MECKLENBURG COUNTY
DEPARTMENT OF ENVIRONMENTAL HEALTH

APPLICATION FOR SOIL INVESTIGATION

APPENDIX II
SITE EVALUATION

SITE INVESTIGATION REPORT
INDIVIDUAL SEPTIC TANK SYSTEM
WITH SUBSURFACE,
SOIL ABSORPTION,
EFFLUENT DISCHARGE

LOT 47
MYRA WAY
HWY 89
200
WILL TAKE 2-10 C SLOPES
100

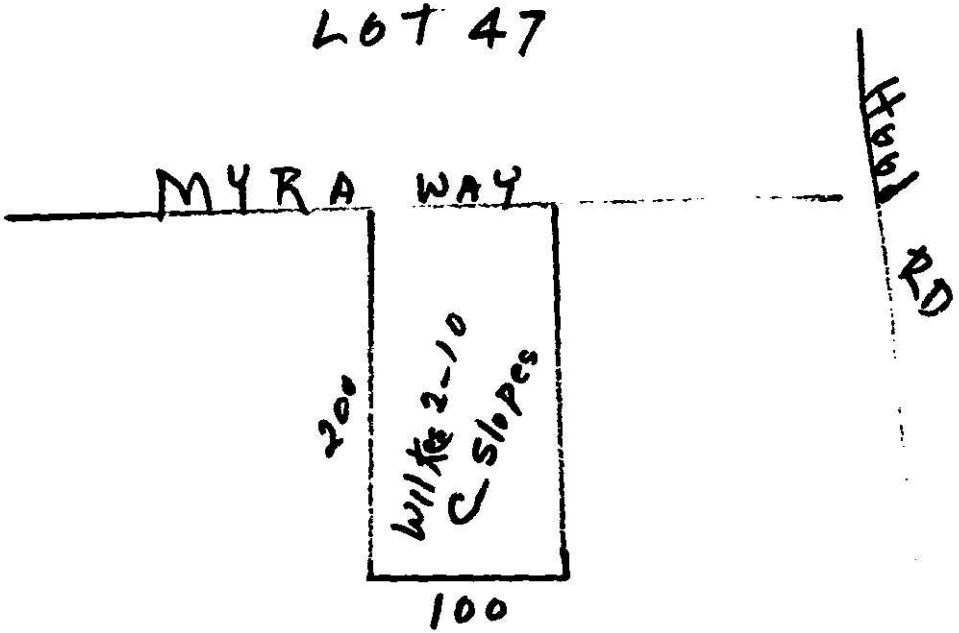
FACTORS	AREA 1	AREA 2	AREA 3	AREA 4
1. SLOPE (%)	S PS 2-10 U	S PS U	S PS U	S PS U
2. SOIL TEXTURE (12-36 in.) (Sandy loamy clayey, Note 2:1 Clay)	S PS 2:1 clay Saprolite U	S PS U	S PS U	S PS U
3. SOIL STRUCTURE (12-36 in.) (Clayey Soils)	S PS MASSIVE U	S PS U	S PS U	S PS U
4. SOIL DEPTH (In.)	S PS 48 U	S PS U	S PS U	S PS U
5. RESTRICTIVE HORIZONS (In.) (Impervious Strata Rock)	S PS Saprolite U	S PS U	S PS U	S PS U
6. SOIL DRAINAGE/CONDITION (External & Internal)	S PS Slow U	S PS U	S PS U	S PS U
7. SOIL PERMEABILITY (Percolation Rate)	S PS SLOW U	S PS U	S PS U	S PS U
8. OTHER (Specify)	S PS U	S PS U	S PS U	S PS U
9. SITE CLASSIFICATION	Unsuitable

As determined under the Rules and Regulations promulgated by the Commission for Health Services, Division of Health Services, North Carolina Department of Human Resources, Raleigh, North Carolina, the soils on the lot described above were found to be unsuitable for the installation of an individual septic tank - soil absorption system, due to the following reason:

Soil Structure Massive
Soil Permeability Unsuitable
